Mr. Patrick Lennberg
Division of Reclamation, Mining and Safety
1313 Sherman Street, Room 215
Denver, CO 80203

RE: M-1977-439 TR07 Response to Adequacy Review No. 2

MARTIN MARIETTA
HOME OFFICE
LARIMER COUNTY, COLORADO

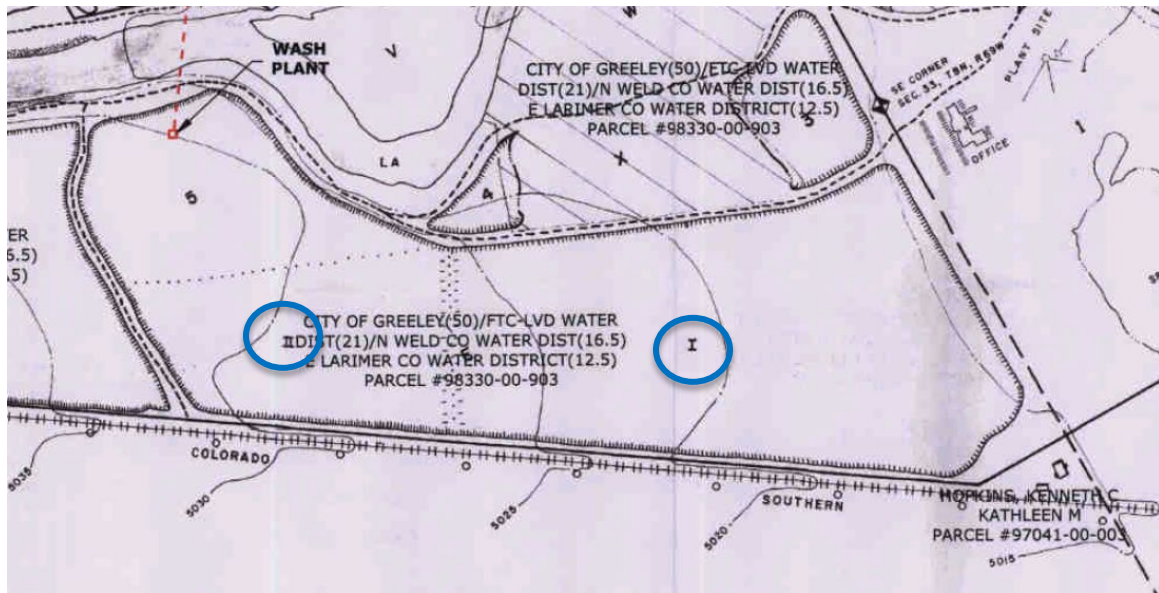
3. A discrepancy with terminology needs to be addressed. In the submitted materials for TR-07, the pit at the northwest side of the site is named E-II and the pit at the southeast side is named E-I. However, older materials in the file for this permit indicate that these are opposite; the northwest area is Pit E-1 and the southeast area is E-II. An example of this is Exhibit C-4, submitted in 2021 for Amendment No. 4 (AM-4)

Response: The Exhibit C-4 from AM-03 and the prior submittals show it the same way that we marked the areas in AM-04. My apologies, I am not following what you want us to do. Can you please clarify?

C3

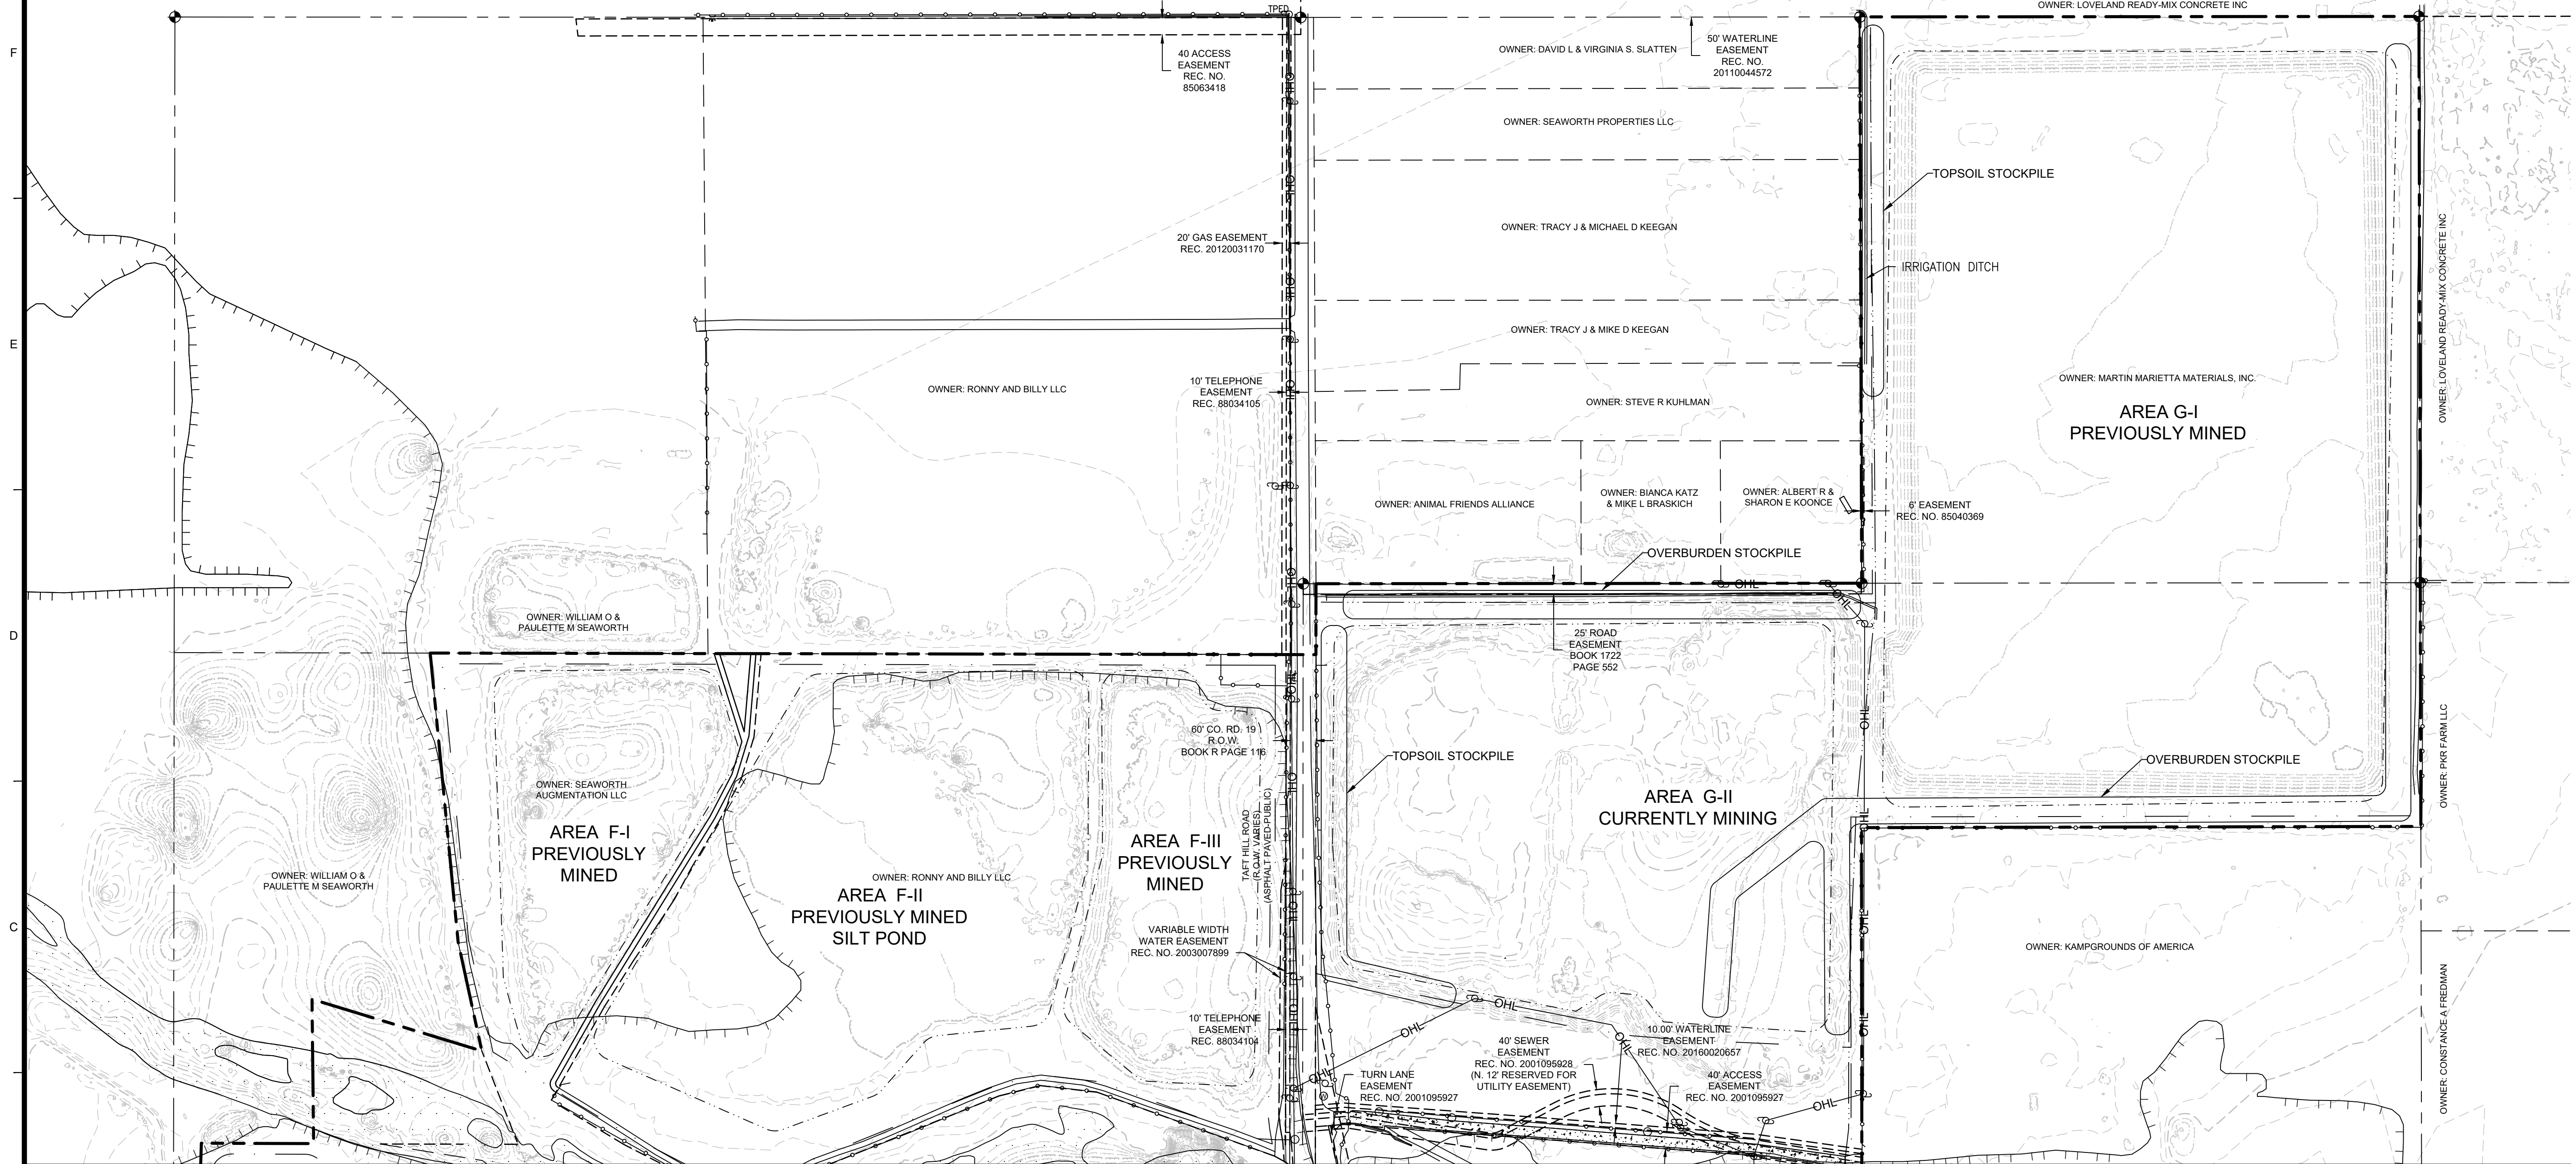
1. The Mining Plan (map in Exhibit C and text in Exhibit D) and the Water Information exhibit (Exhibit G) should be revised to include a discussion of the levees (or high ground) that prevent inundation of the area at the northwest corner of the site. The text should also include a commitment to maintain these structures (or elevated ground) to prevent future inundation.

Response: Exhibit C has been updated to identify this naturally occurring elevated ground. Exhibit D has been updated by adding your requested language to the bottom of page 5. Exhibit G has been updated with your requested language as a new page 12.

Note: Based on the Flood Evaluation completed by Anderson Consulting Engineers, Inc. dated January 8, 2024, there is high ground in the northwest corner of Area E-II what would prevent inundation of the area during a flood. Martin Marietta commits to maintain this naturally occurring elevated ground as it is within the designated mining setbacks for the property boundary and river.
